Circuit Change

PROBLEM: You may have the complaint that the TV SCART RGB output is not switching automatically.

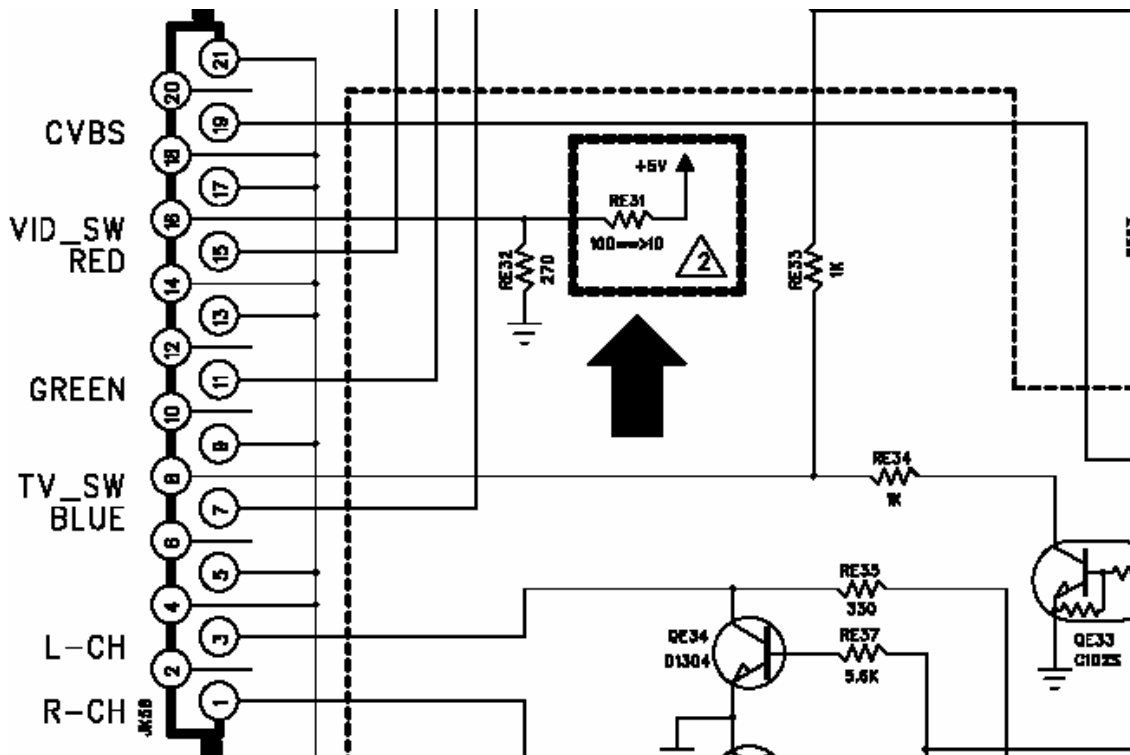
CAUSE: The drive current of some television sets is not sufficient to switch the RGB output.

Delete RE31 100 ohm resistor on video board.

Add a 10 ohm resistor between PIN 16 of SCART connector (one leg of RE31) and +5V rail(one leg of R554) on video board. See photo and schematic diagram.
